# Arboricultural Consultant's Site Supervision & Monitoring Record: 06.01.25

1.	Development Site Address:	2. Local Planning Authority (LPA):
	11 Clare Lawn Avenue East Sheen Richmond Upon Thames SW14 8BE Job No. 22.5999	Environment Directorate / Development Management London Borough of Richmond upon Thames

3.	<b>Proposal:</b> Demolition of existing ground floor rear conservatory extension. Erection of part two storey, part single storey side and rear extension with a hipped pitched roof to the front, side and rear of the first floor. Roof extension to the main roof of dwellinghouse. Insertion of rooflights. Extended patio to the rear to replace existing. Rear dormer roof extensions

Photo 2.

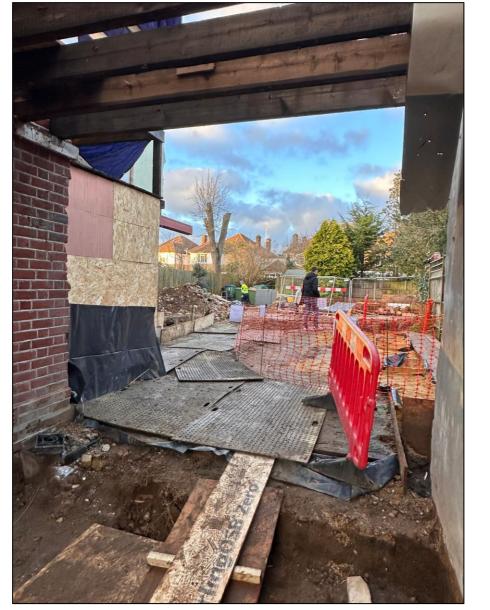
2. Ref. SSMR\_18 Dec 2024 section: 5.4.4.1. Temporary ground protection must be fully installed over the minimum area of RPA of T1

Temporary ground protection has now been constructed over the RPA of T1, together with a temporary protection barrier (TPB) around the edge of the RPA, to create a construction exclusion zone over the RPA of T1, as shown in Photo 2 below.

The TPB may be moved only to allow site access for the auger rig or digger, but this must be re-erected immediately the rig is in position. The auger rig or digger must be positioned outside the construction exclusion zone at all times during the auger excavation of the piles.
